SUBJECT: SUPPLEMENT IN RESPONSE TO DATA ADEQUACY
COMMENTS ON THE APPLICATION FOR CERTIFICATION FOR
THE WALNUT CREEK ENERGY PARK (05-AFC-02)

In Response to Data Adequacy Review

Walnut Creek Energy Park

(05-AFC-02)

Power Flow Diagrams

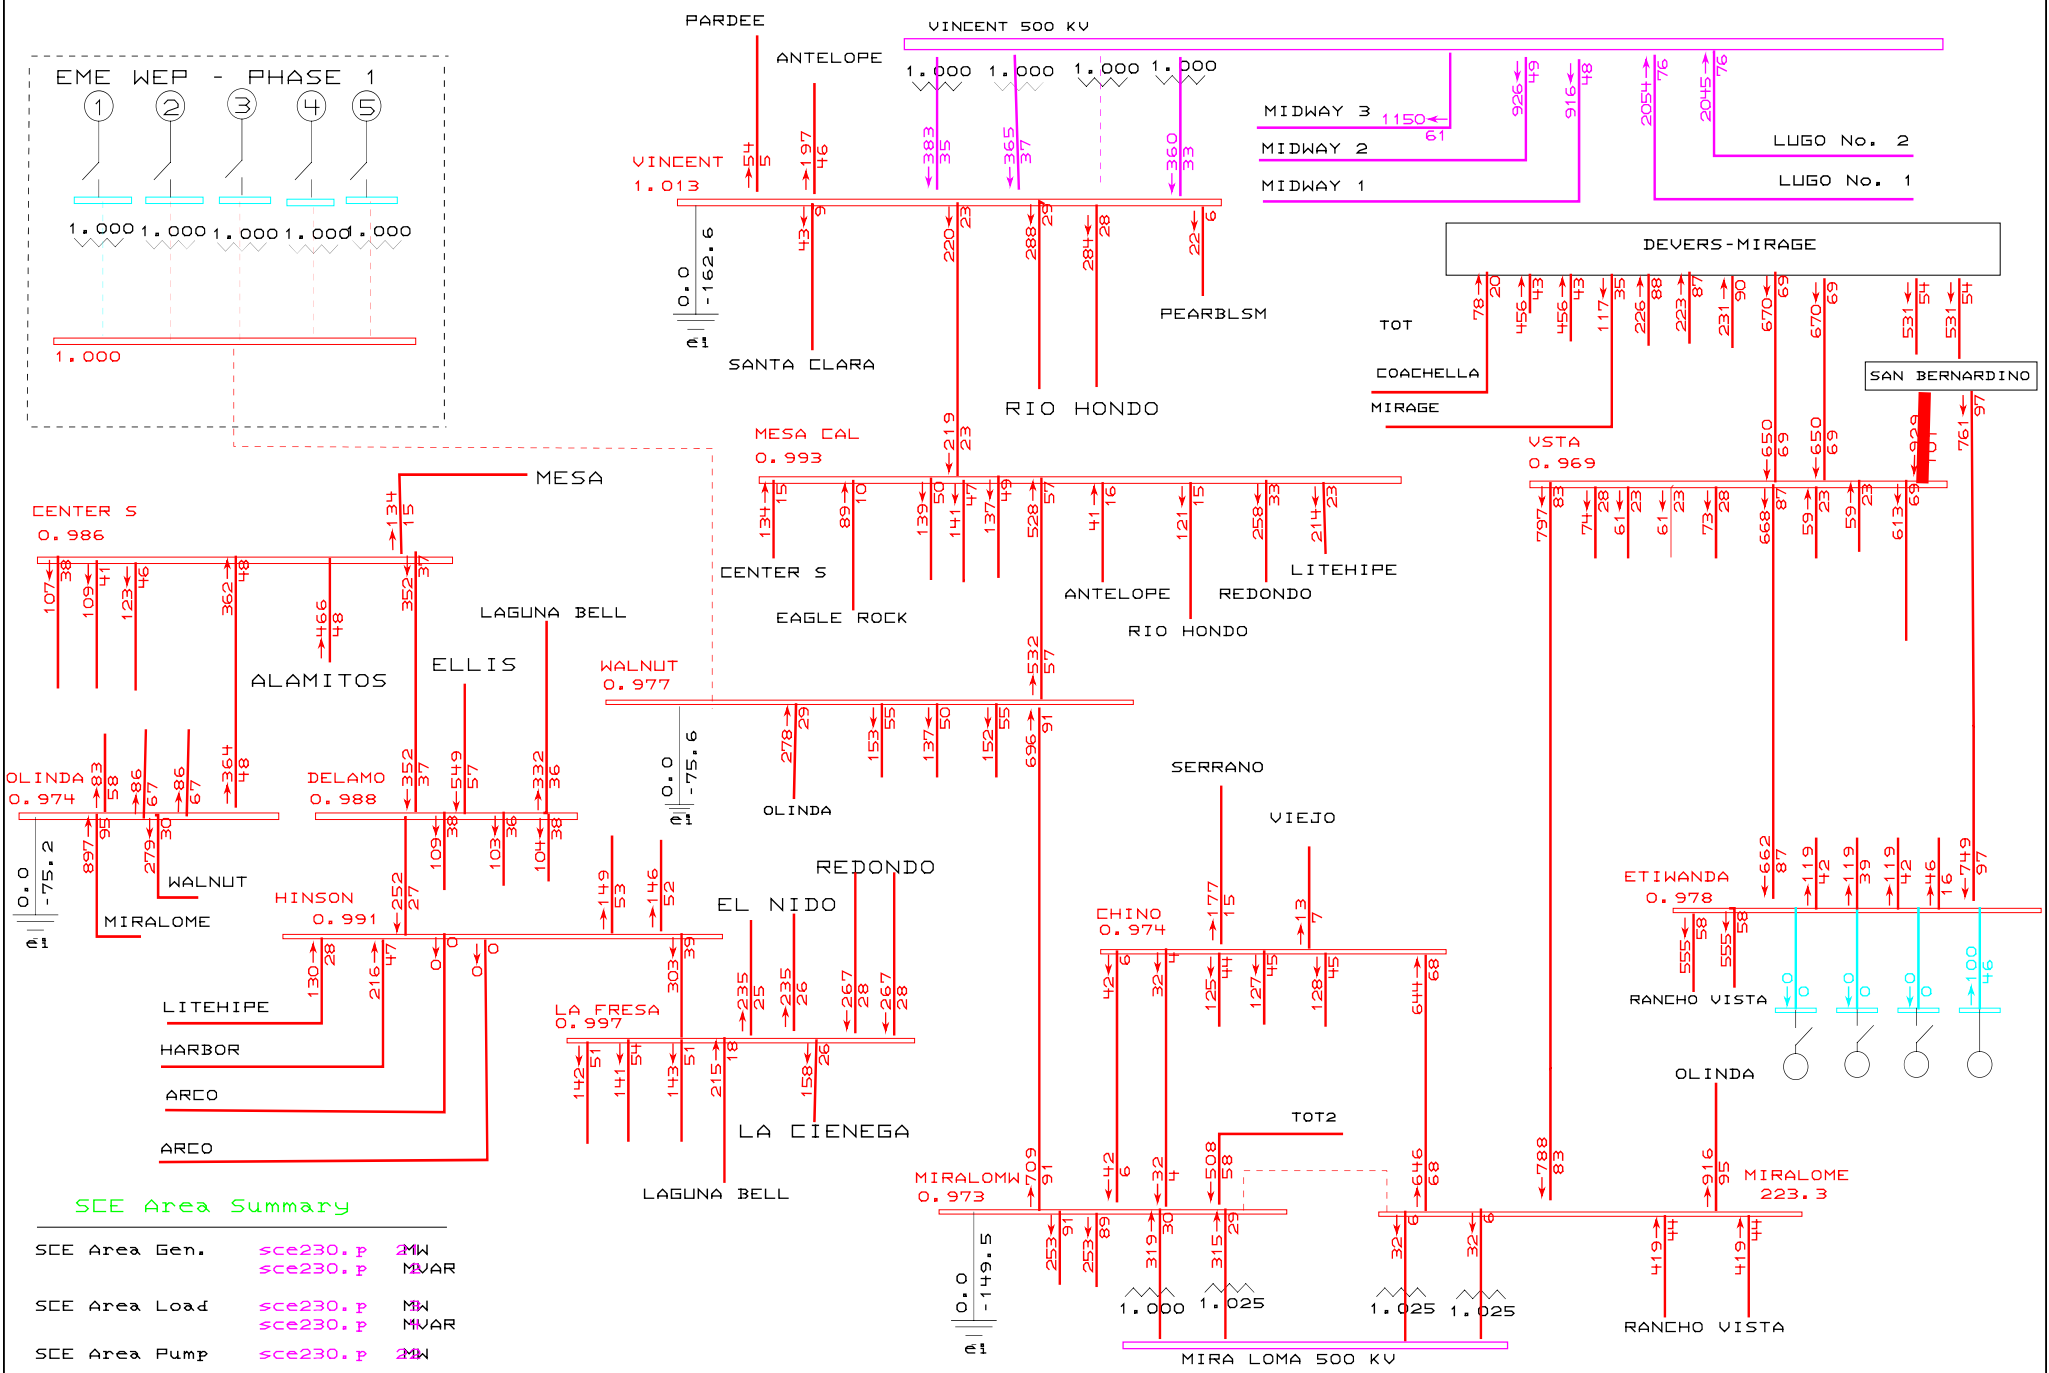
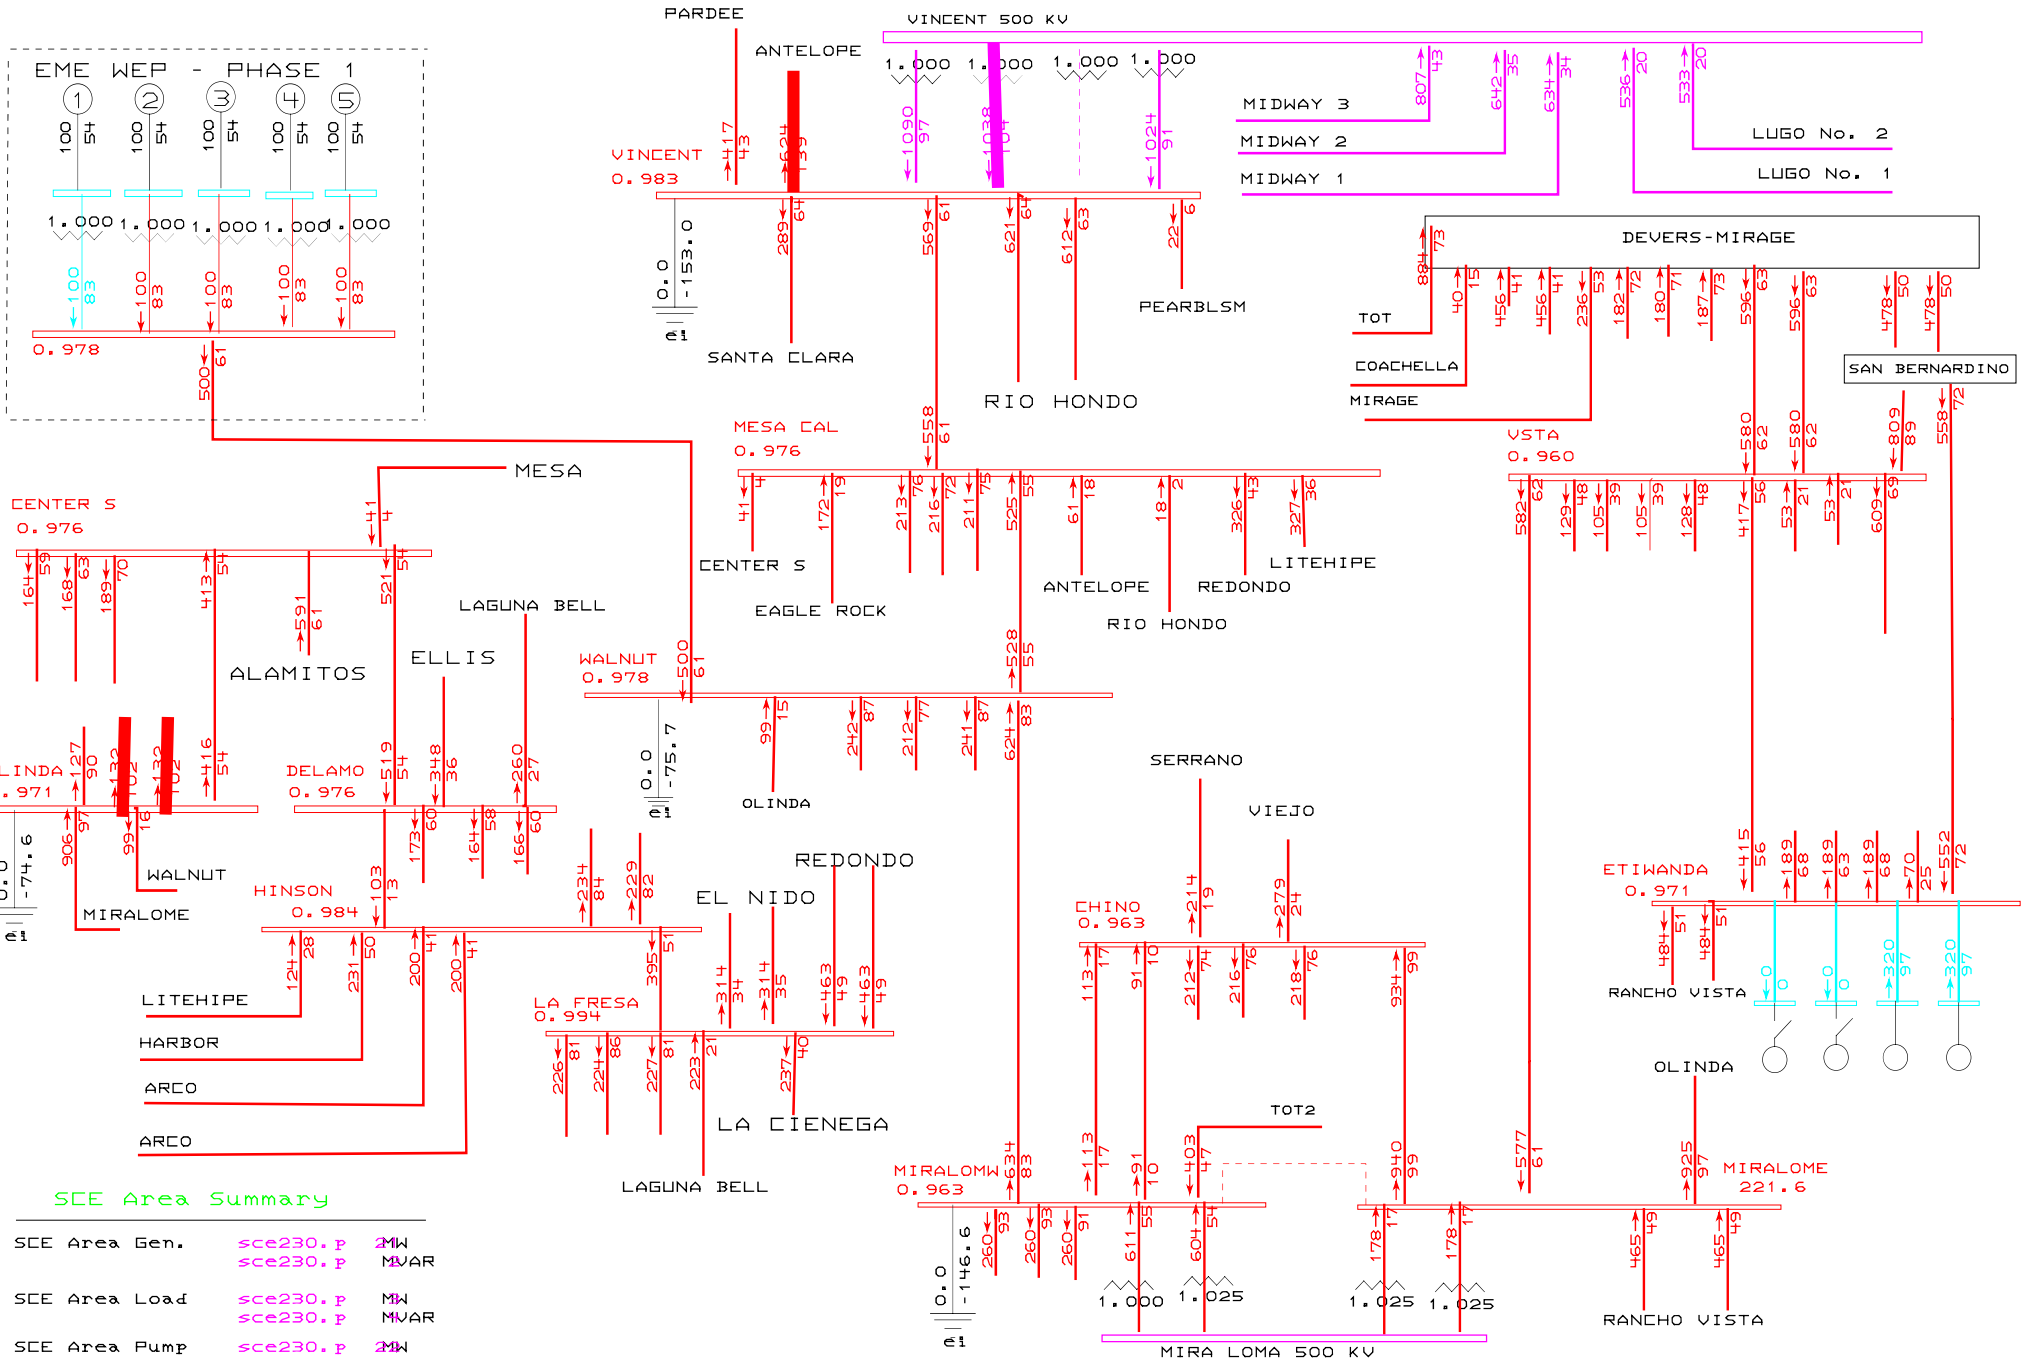
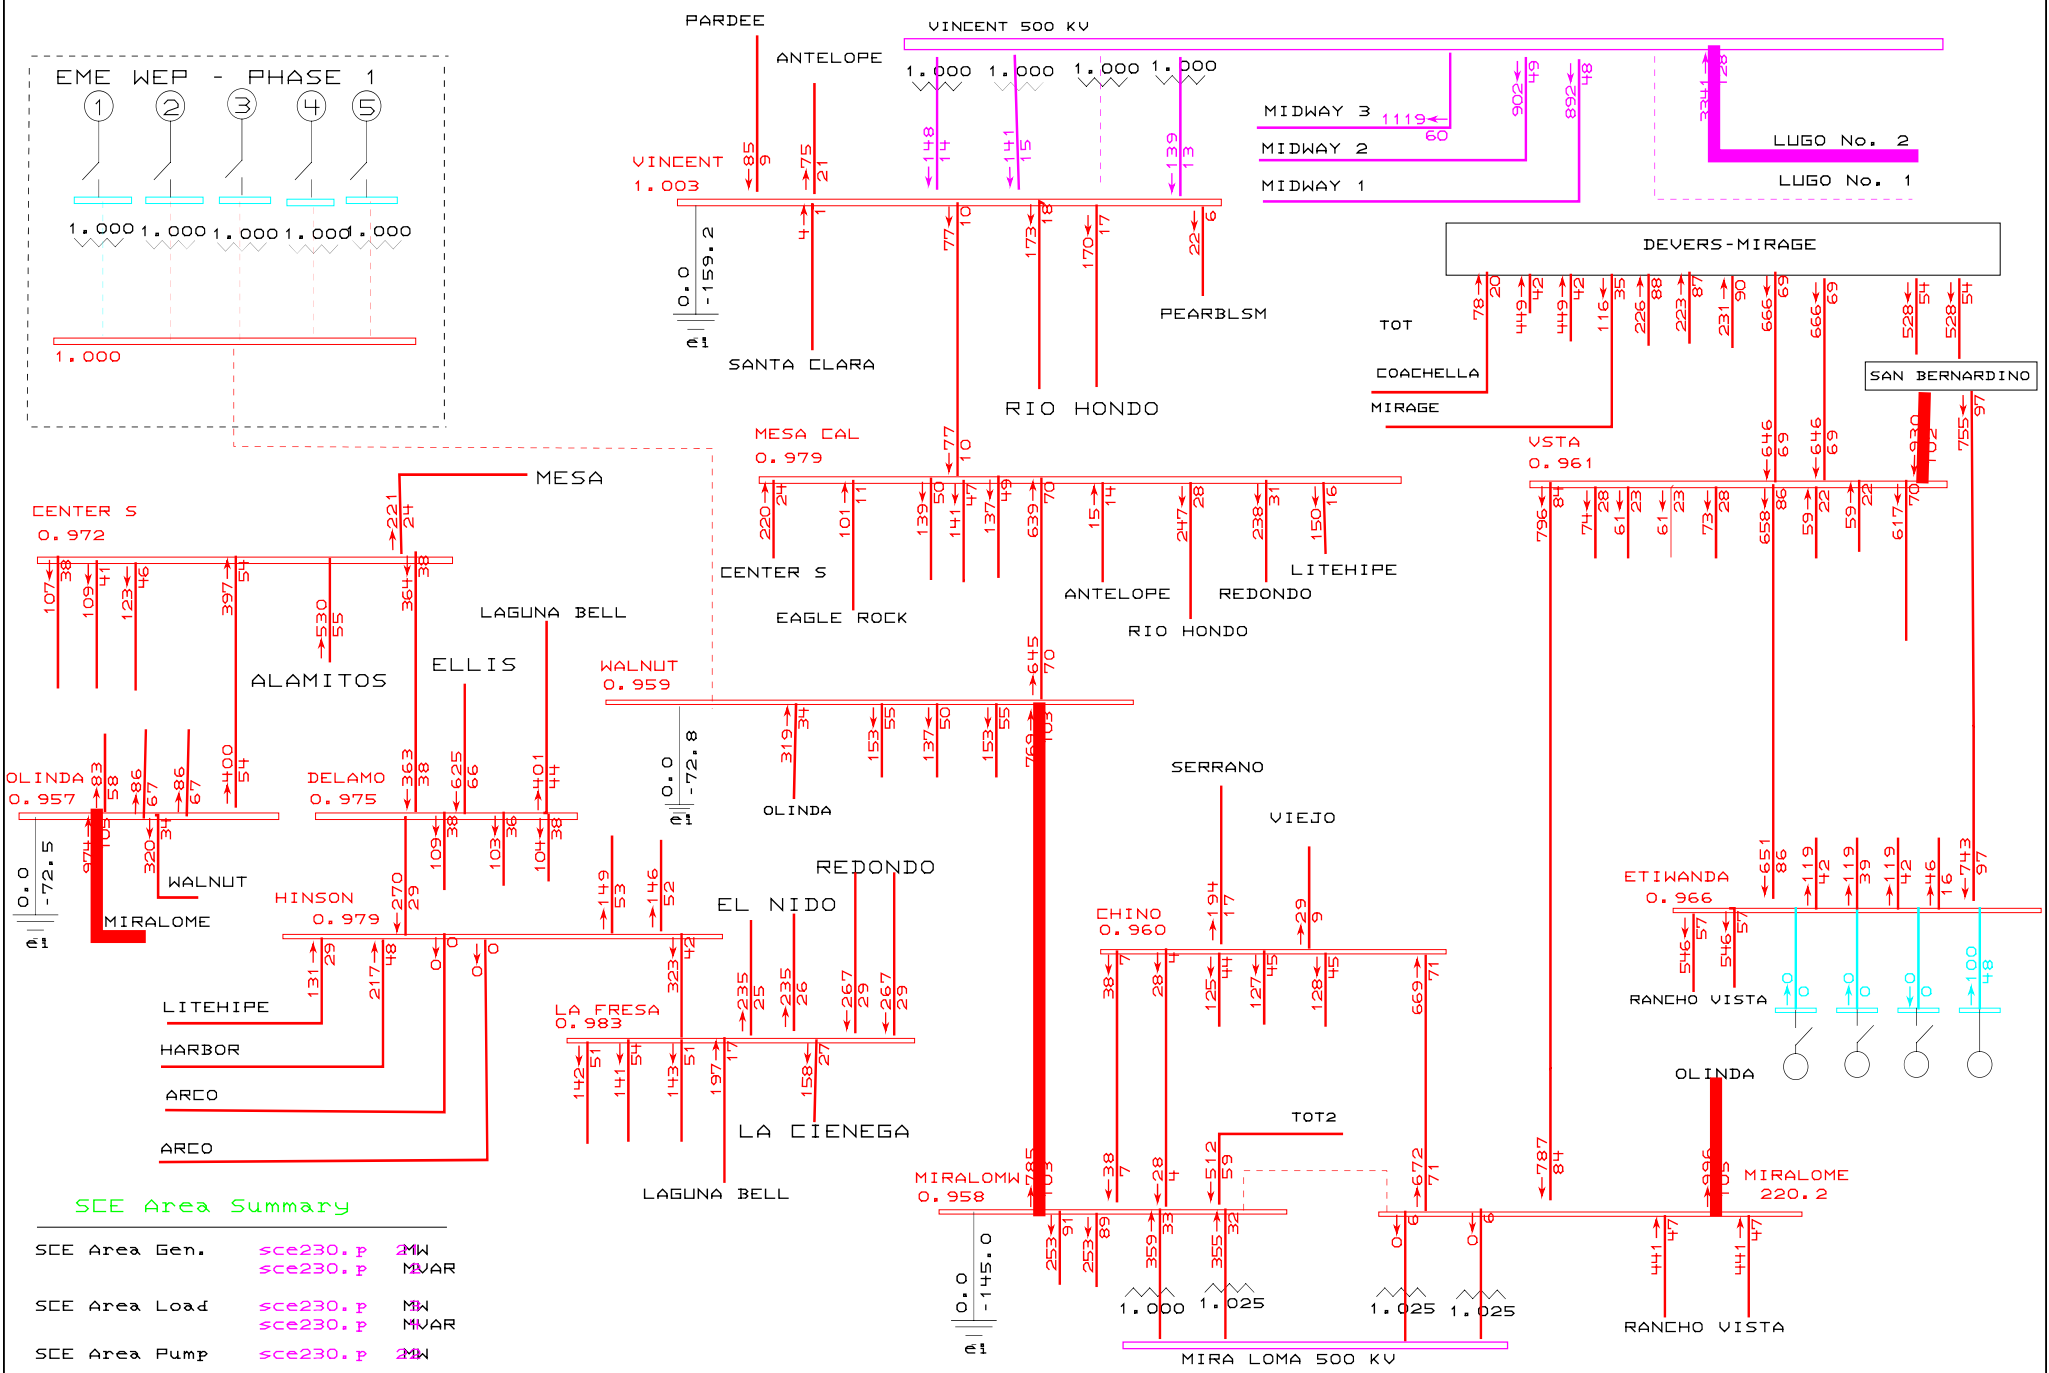
Provide power flow diagrams (MVA, % loading & P. U. voltage) for all N-1 and N-2 contingencies where overloads or voltage violations appear.

Response – Power flow diagrams for cases for which the WCEP would aggravate existing transmission system overloads are attached.
